This Service Information bulletin supersedes SI B63 02 08 **dated October 2009**.

#### Rear Bulb Failure

E92 (3 Series Coupe) vehicles produced up to May 30, 2009

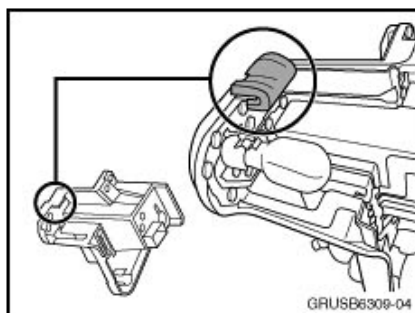
- Poor fit between the bulb and bulb holder (old design bulb holder)
- Bulb failure caused by vibration (new design bulb holder)

- **NEW** Before installing the new part, apply a foam rubber anti-vibration strip as shown.
- Install the bulb holder in the vehicle.

For bulb holders produced **before** date code 21.01.08:

- Replace the complete bulb holder housing with an updated part. The replacement part is supplied complete with bulbs.

For bulb holders produced **after** date code 21.01.08:

- Do not replace the bulb holder. Replace any failed bulbs.
- **NEW** Apply the anti-vibration strip as described above before reinstalling the bulb holder.

Note 1: All bulb holders on vehicles up to May 30th, 2009 must have the anti-vibration strip applied before the bulb holder is installed in the vehicle.
